Final Plat - Revere Trails First Addition

Village of Windsor

Plat consists of 11 lots, 2 Outlots, 26.01 acres.

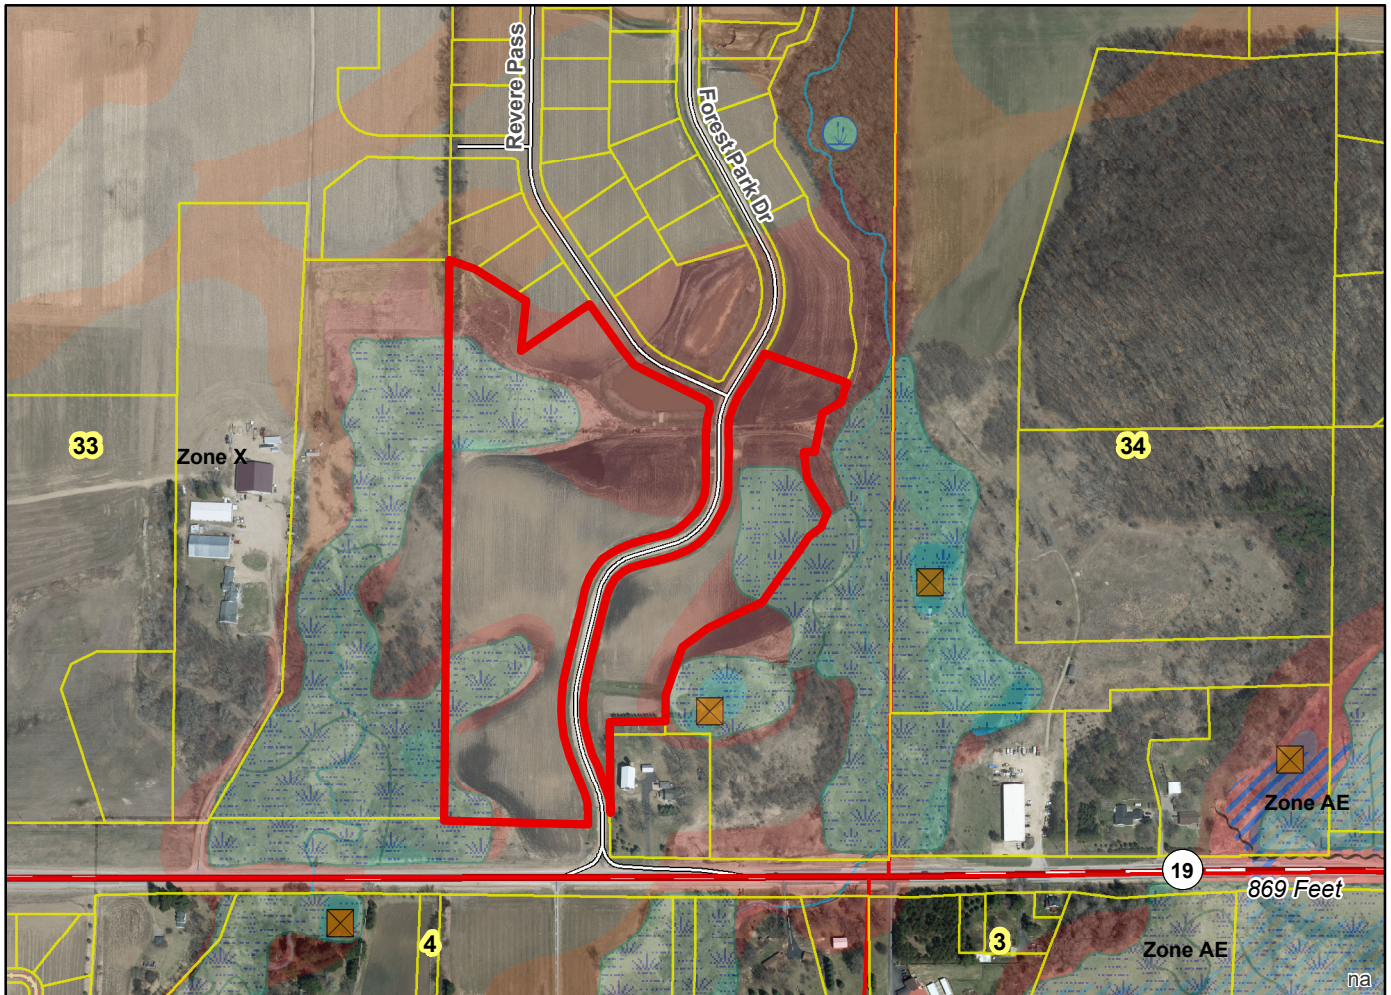
Parks - OL 7 and 8 shown as for open space and stormwater management.

Drainage Channels - Drainage arrows shown on the plat.

Other Development - Stormwater easements shown throughout the plat.

Outlots 7 and 8 reserved for stormwater management.

Motion to certify with no objections: _____, Second: _____ Vote: _____
